Addendum No. 03

SUBJECT: Willamette River: Stormwater Source Control Improvements Project
Lower Columbia River, Northeast Portland, Stadium Freeway
Multnomah
Grading, Drainage, Paving, Signing, Illumination, and Roadside Development
(Bids Closing April 30, 2026)

1. Plan sheets BA03, BA04, BA08, C201, C581, ES01, FA201, FB201, GA201, HA201, HA401A, HB202, PA201, S02, TA201 are replaced with revised plan sheets BA03, BA04, BA08, C201, C581, ES01, FA201, FB201, GA201, HA201, HA401A, HB202, PA201, S02, TA201.

SHEET NO.
ES01

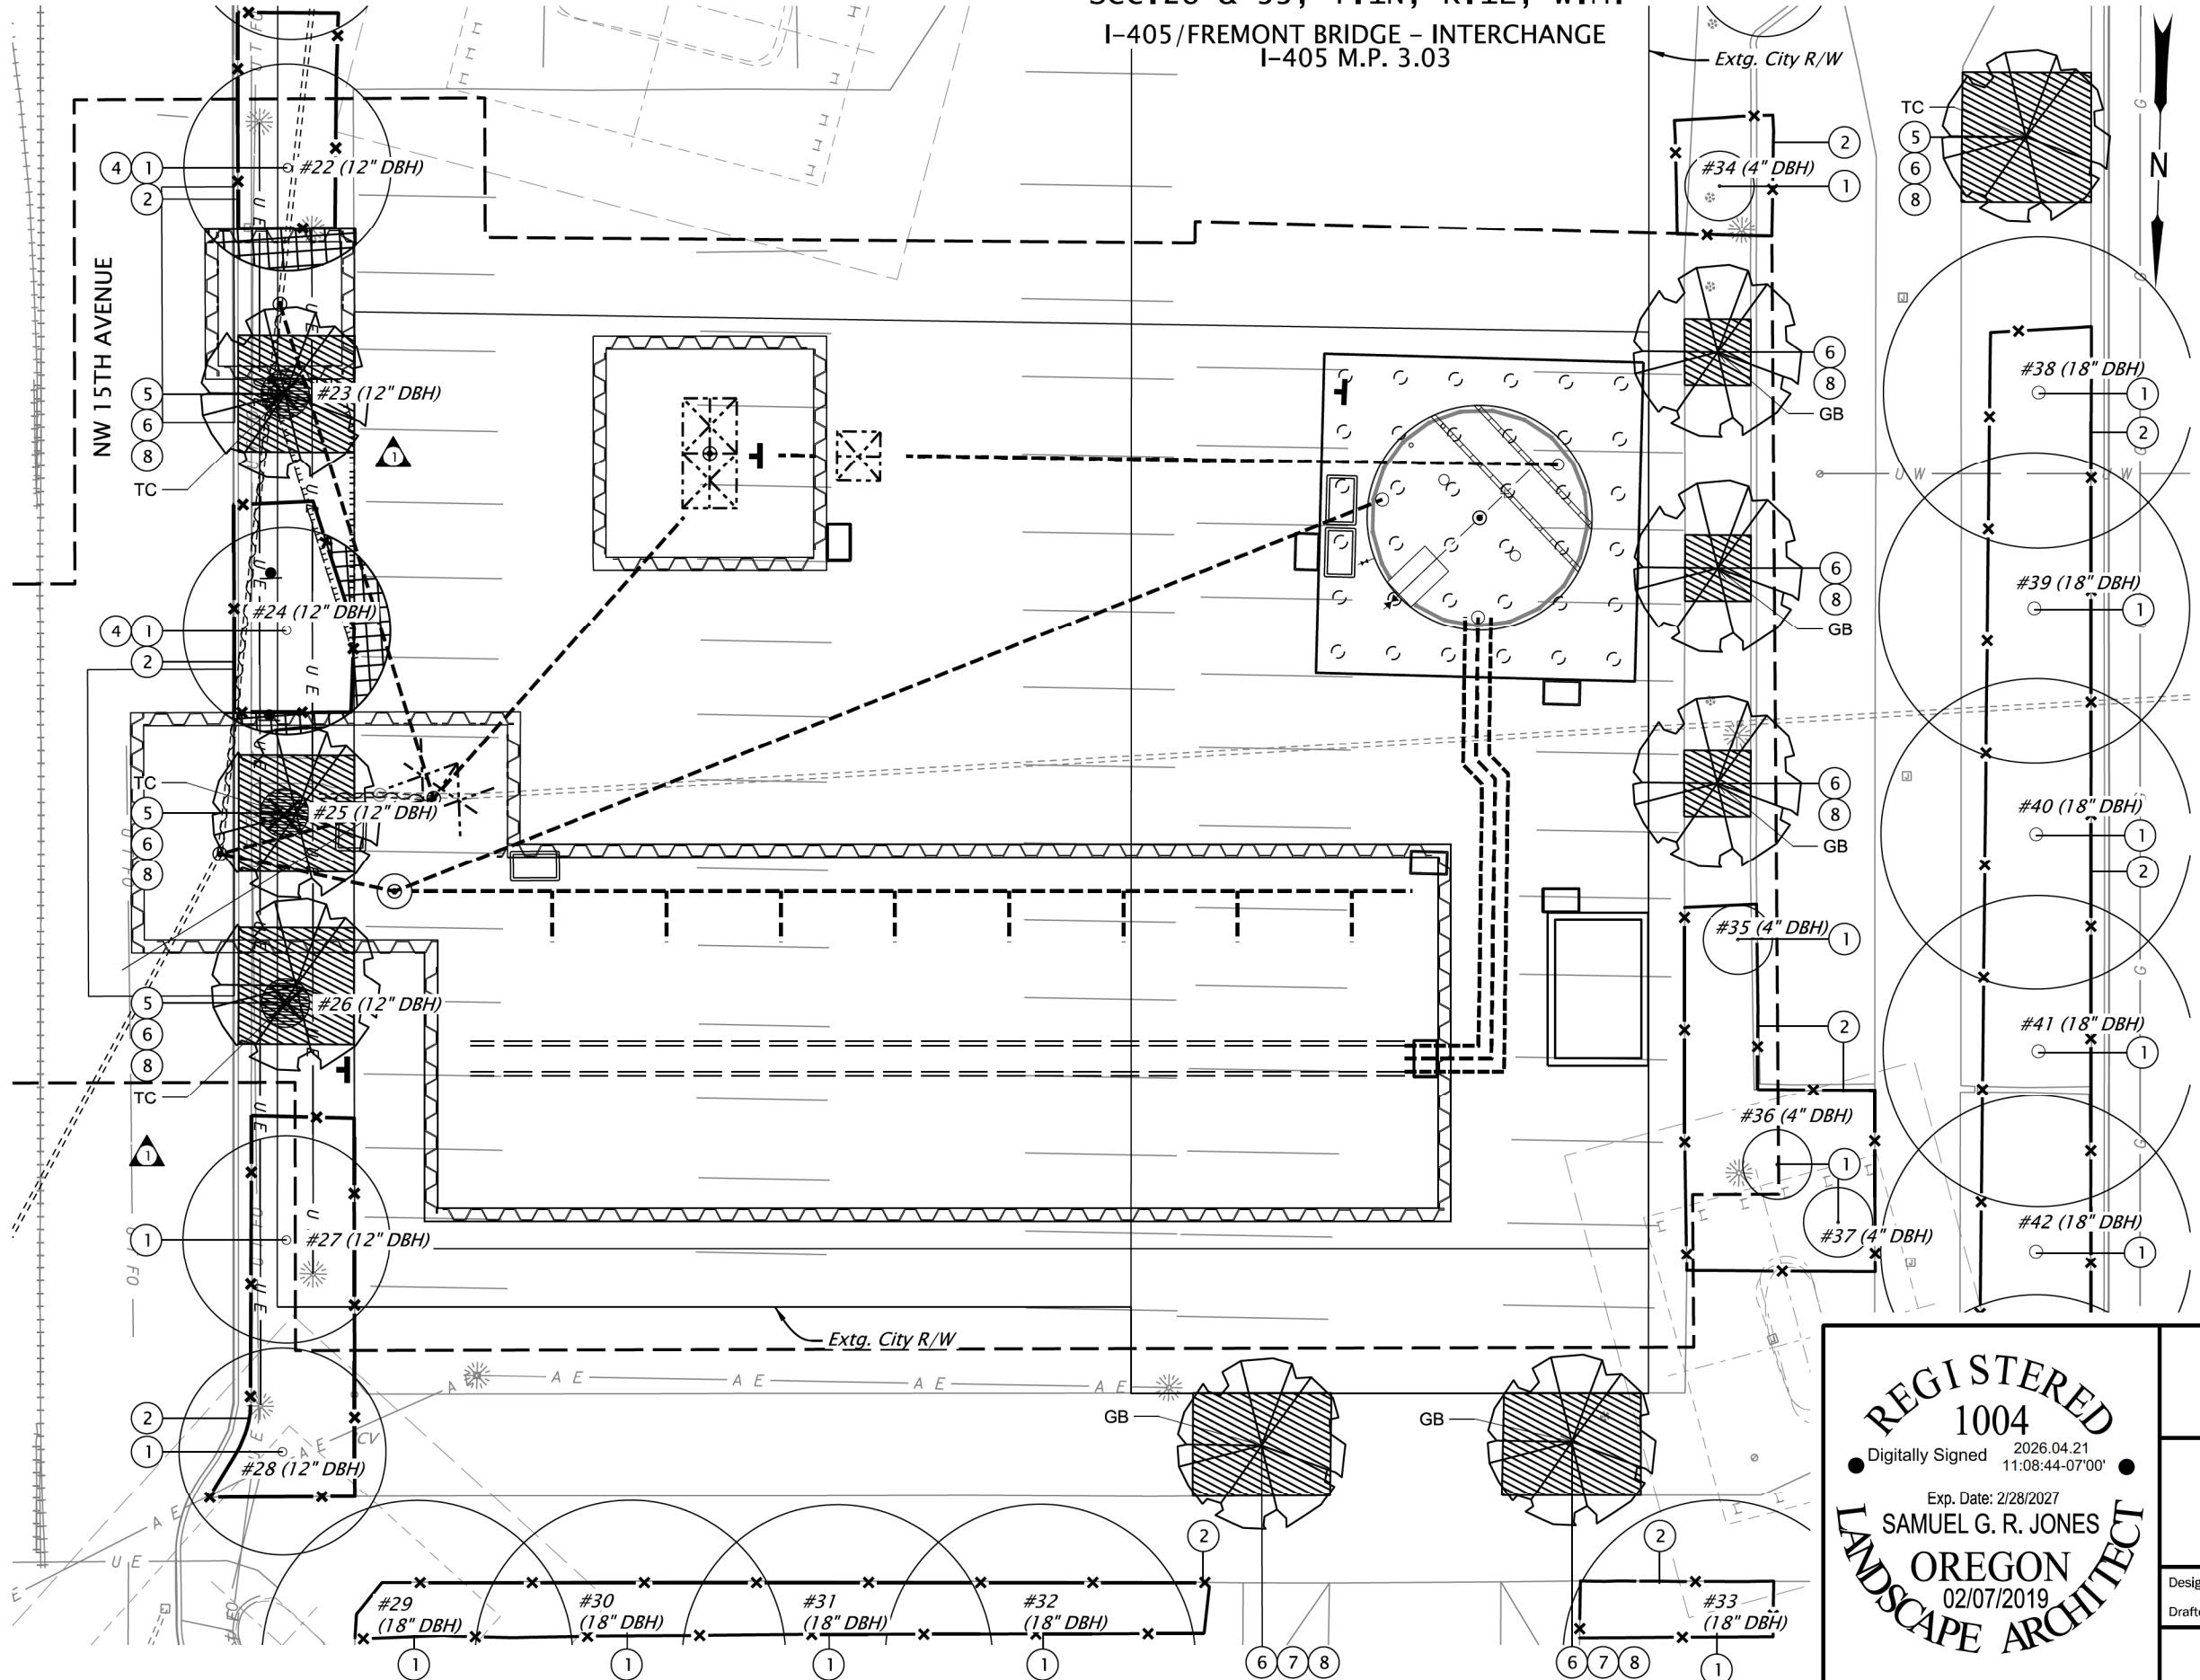
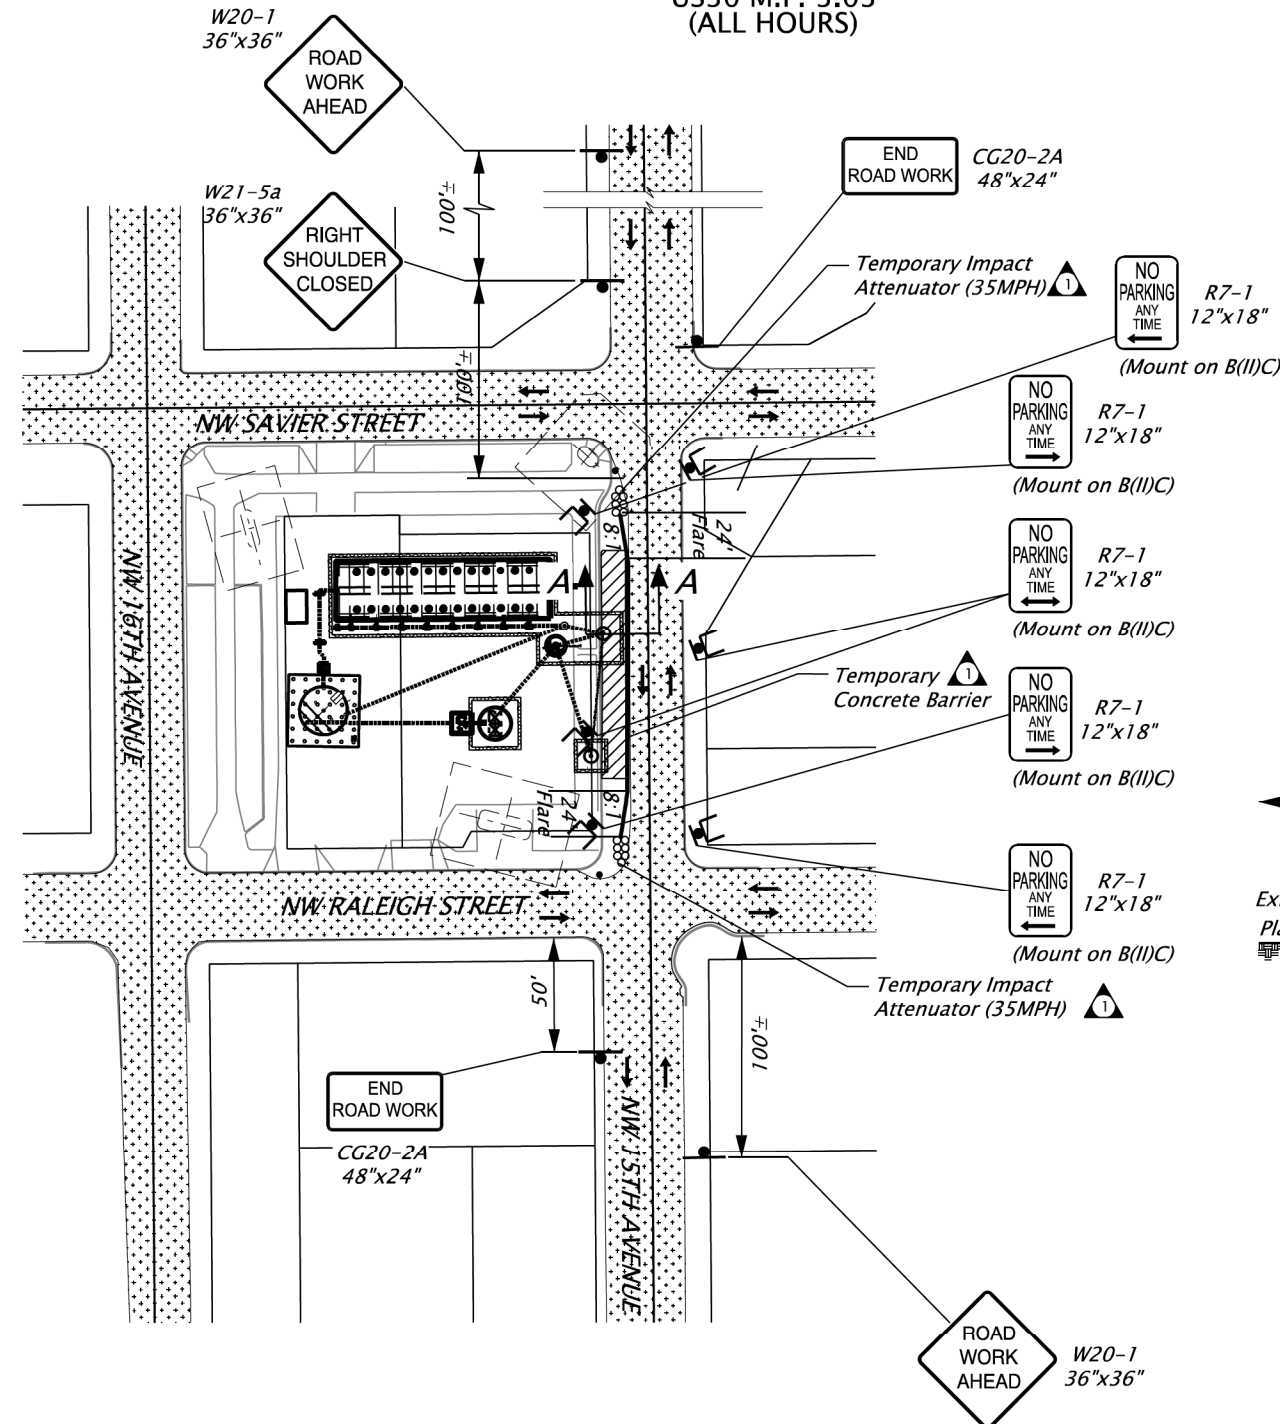
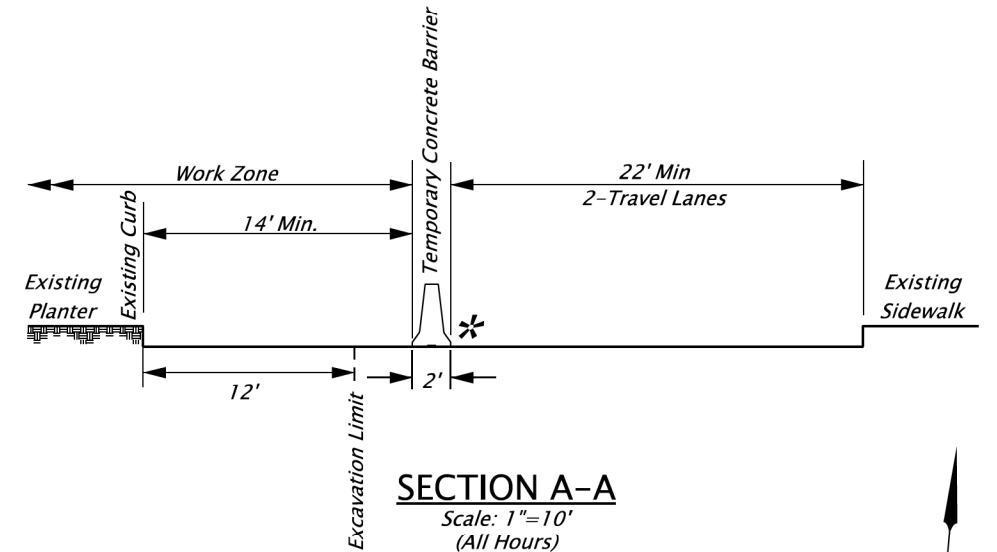
No.	DATE	REVISIONS	BY
1	04-16-26	Traffic control plan change.	J.M.

ROADSIDE DEVELOPMENT PLANTING PLAN/SECTION SHEET NO. FA201

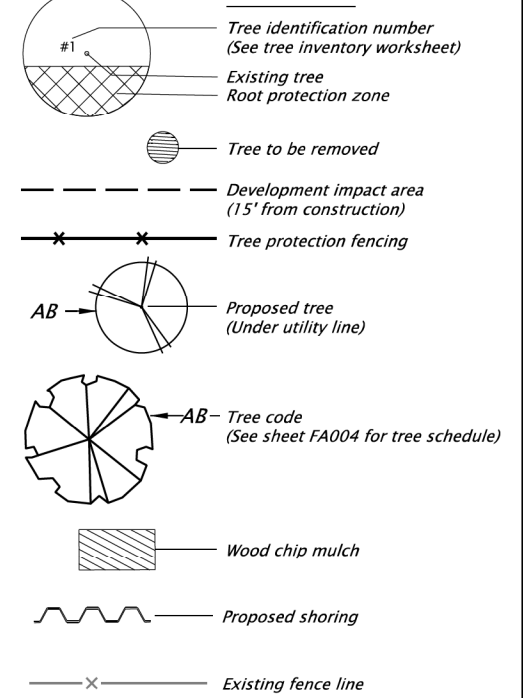
No.	DATE	REVISIONS	BY
①	04-16-26	Removed 42" extg. storm sewer pipe	A.P.J.

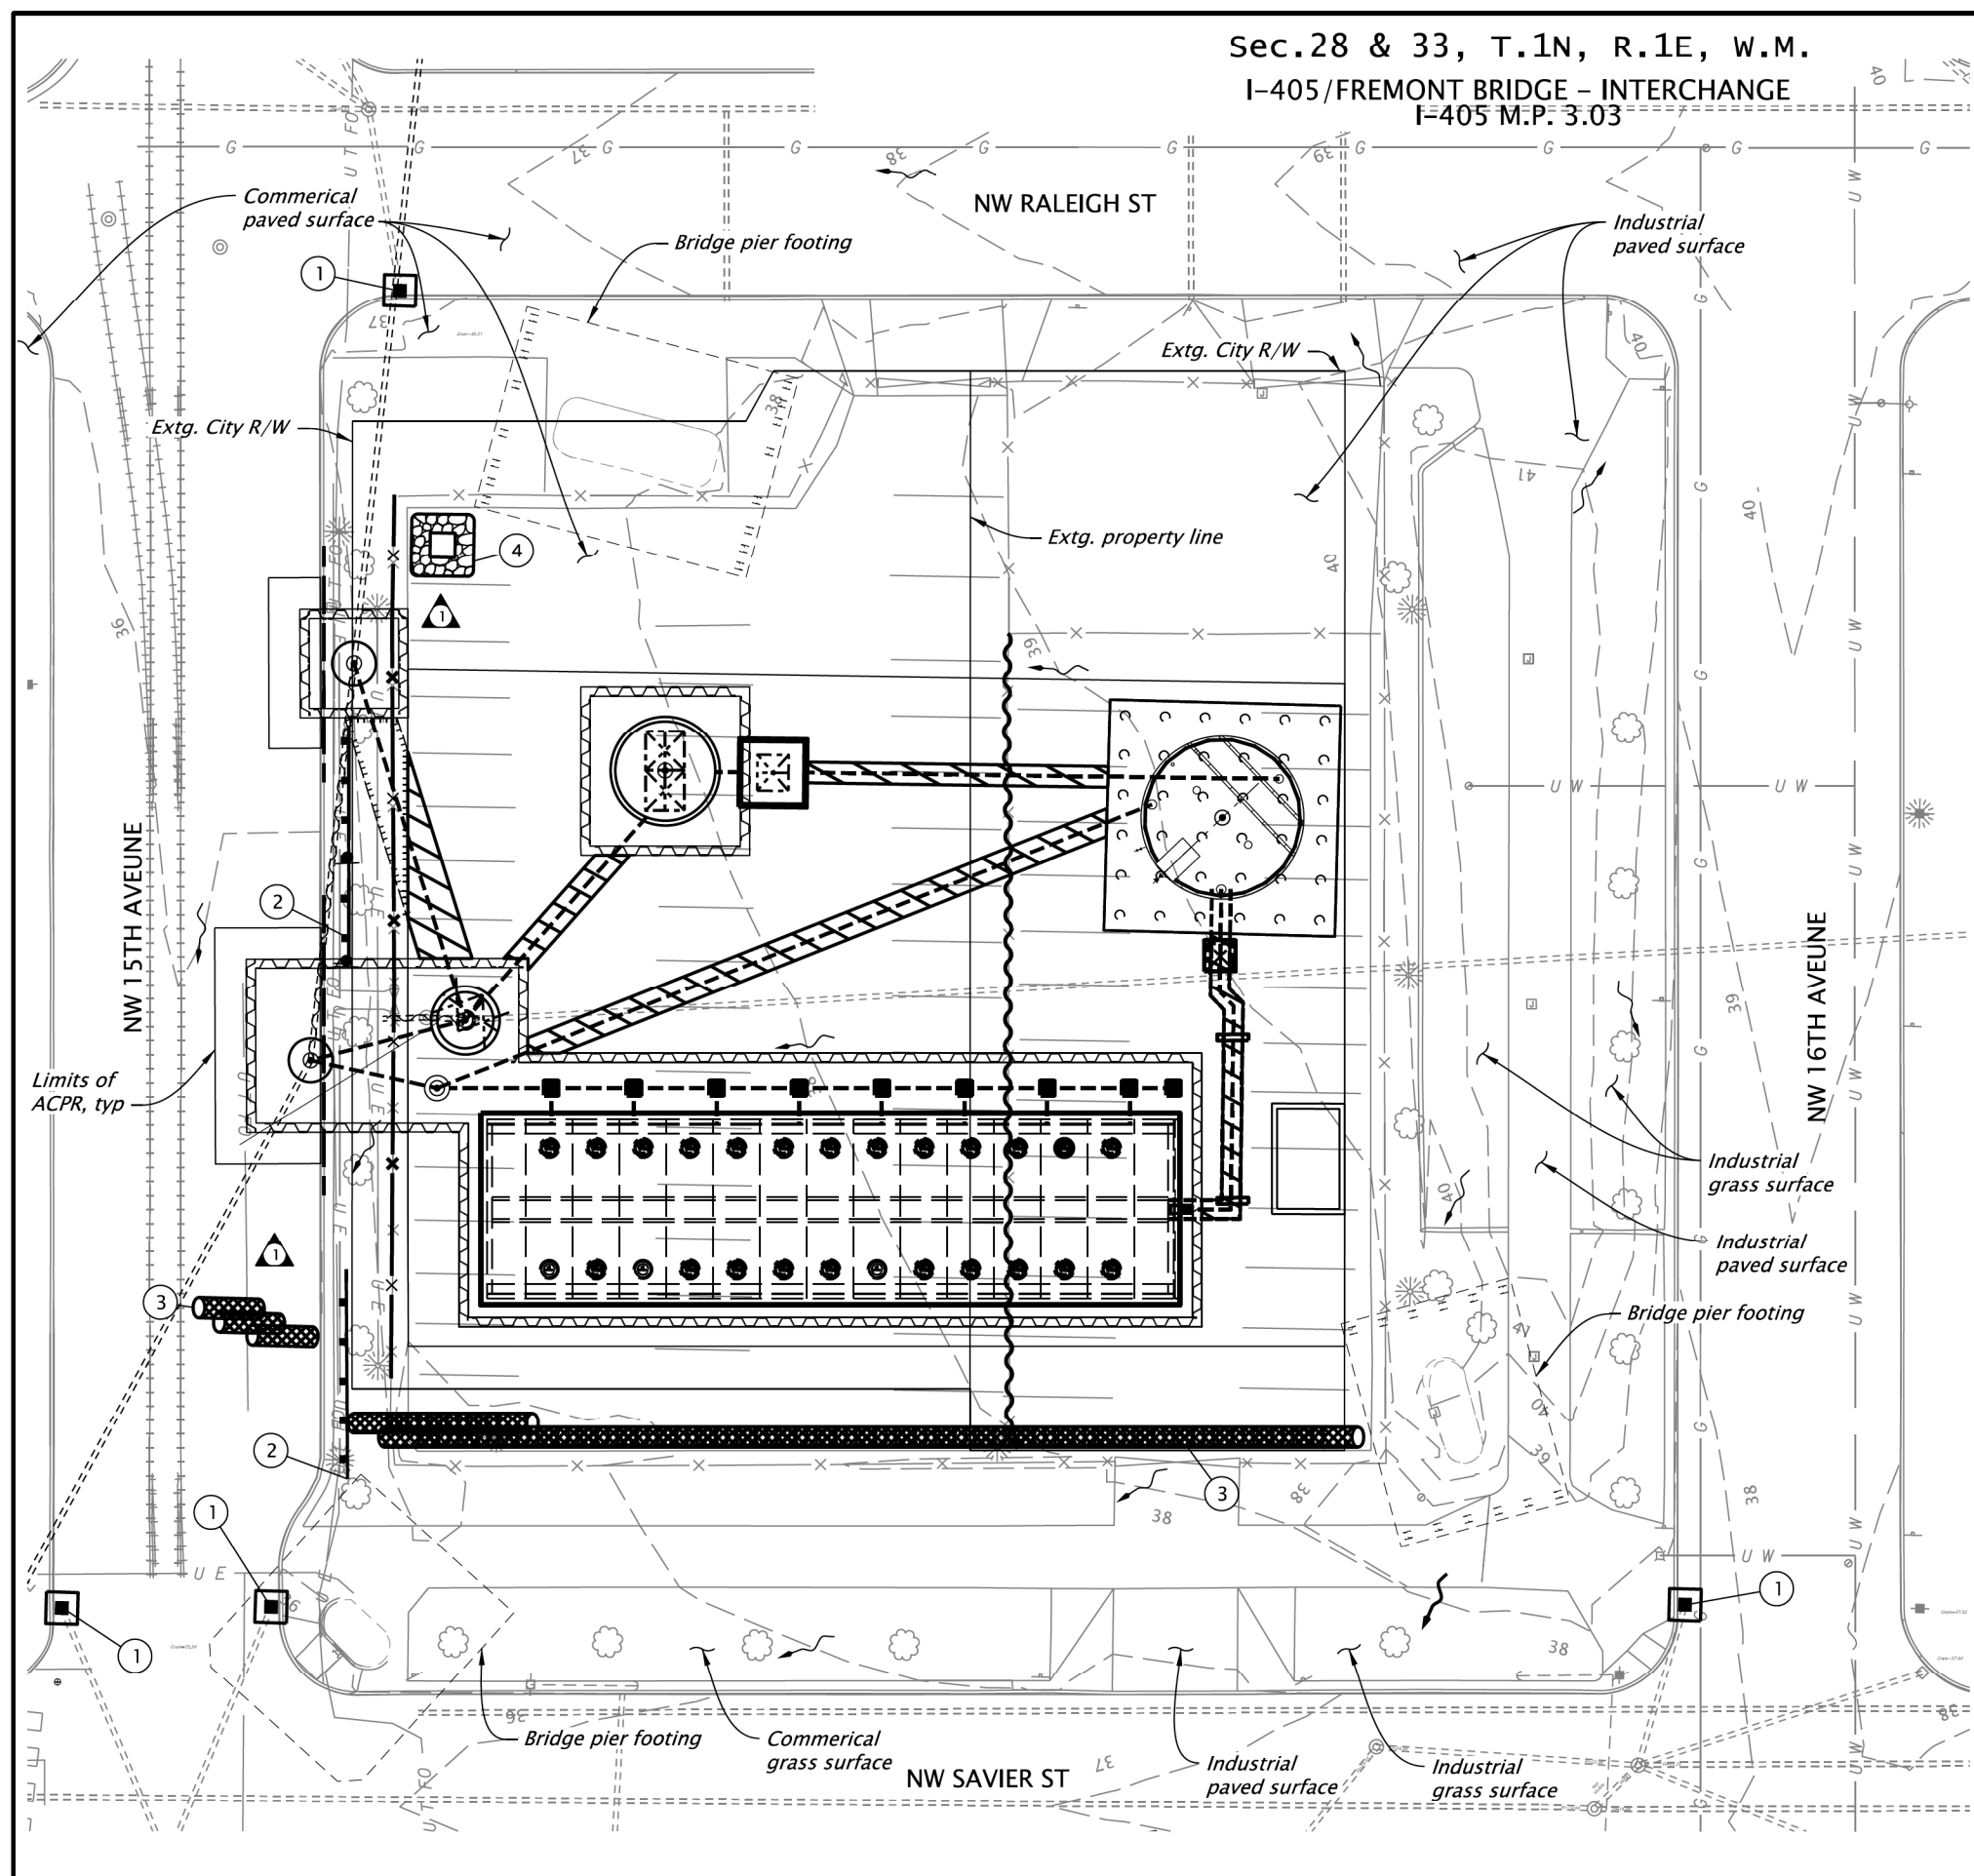
No.	DATE	REVISIONS	BY
①	04-16-26	Removed 42" extg. storm sewer pipe	J.G.H.
